***RE: WAREHOUSE, ALBUQUERQUE DIVISION YARD, MRGCD (LI4-D40). GRADING
AND DRAINAGE PLAN FOR BUILDING PERMIT APPROVAL. ENGINEER'S
STAMP DATED MAY 22, 2000.***

RE: REVISED DRAINAGE PLAN FOR M.R.G.C.D. ALBUQUERQUE DIVISION
YARD(L14-D40) REVISION DATED 6/20/95.

RE: DRAINAGE PLAN FOR MRGCD ALBUQUERQUE DIVISION YARD (L14-D40)
ENGINEER'S STAMP DATED 5/26/95.

SIDEWALK CULVERT: HYDRAULICS FOR SITE IMPROVEMENTS TO THE M.R.G.C.D. ALB. DIV. YARD

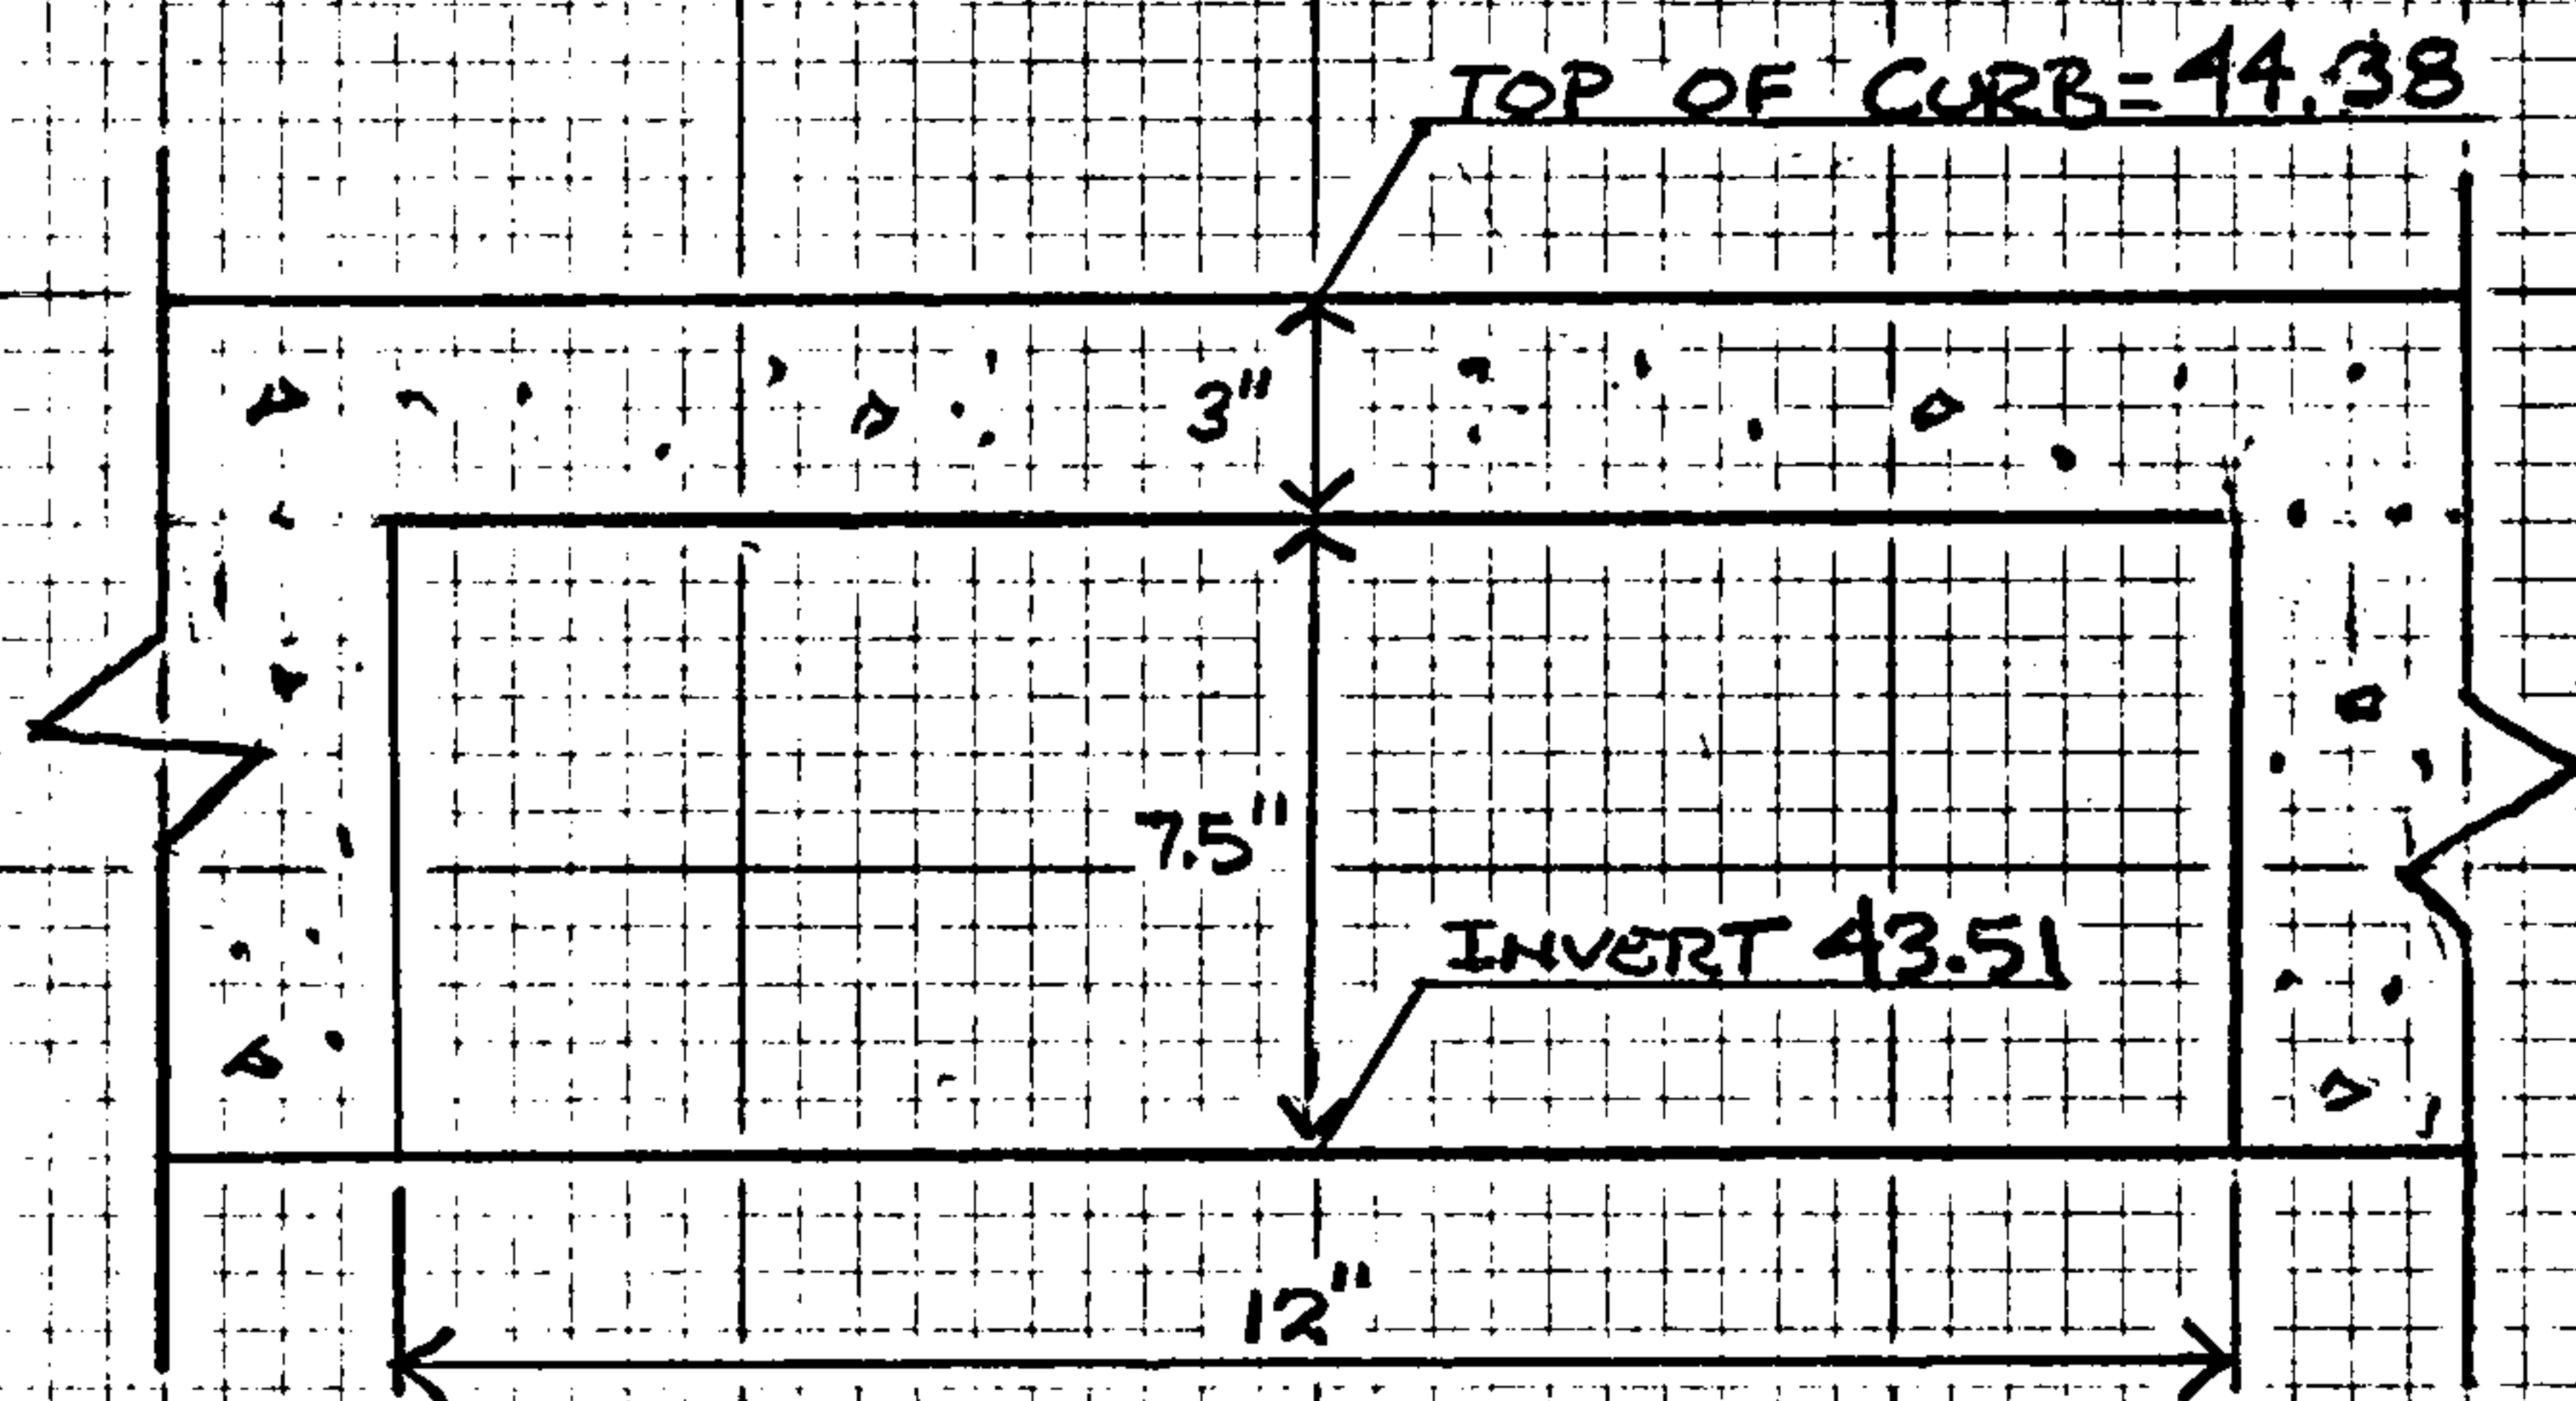
1. Top of curb elevations to mean sea level on second street.
2. Hydraulics for the proposed sidewalk culvert compute the entrance capacity.
3. Basin 3 shows an increase in volume, retention ponds are not allowed by ordinance. They must be drained within 24 hours.

PROBLEM: WHAT IS THE ENTRANCE CAPACITY FOR A
1'-WIDE SIDEWALK CULVERT (C.O.A. STD. DWG. 2236).

1. We have revised the grading and drainage plan to show top of curb elevations within the Second Street Right-of-Way to reflect mean sea level elevations.
2. Hydraulic calculations for the proposed sidewalk culvert are attached. The sidewalk culvert was analyzed using the orifice equation. The computed capacity under submerged conditions is 2.30 c.f.s..
3. Per your conversation with Mr. Leonard Utter, we have prepared an agreement which holds harmless the City for the construction of a retention pond within Basin 3 as shown in the grading and drainage plan. The retention pond is necessary to drain the east side of the Albuquerque Division Yard. Drainage of Basin 3 to Second Street is not possible because the Basin 3 is lower than the top of curb at Second Street.

SOLUTION: ENTRANCE CAPACITY DETERMINED USING THE
ORIFICE EQUATION FOR RECTANGULAR SUBMERGED
ORIFICES.

$$Q = CA\sqrt{2gH}$$

$$Q = (0.61)(0.625)\sqrt{(2)(32.2)(0.563)}$$

$$= \underline{\underline{2.30 \text{ cfs}}}$$
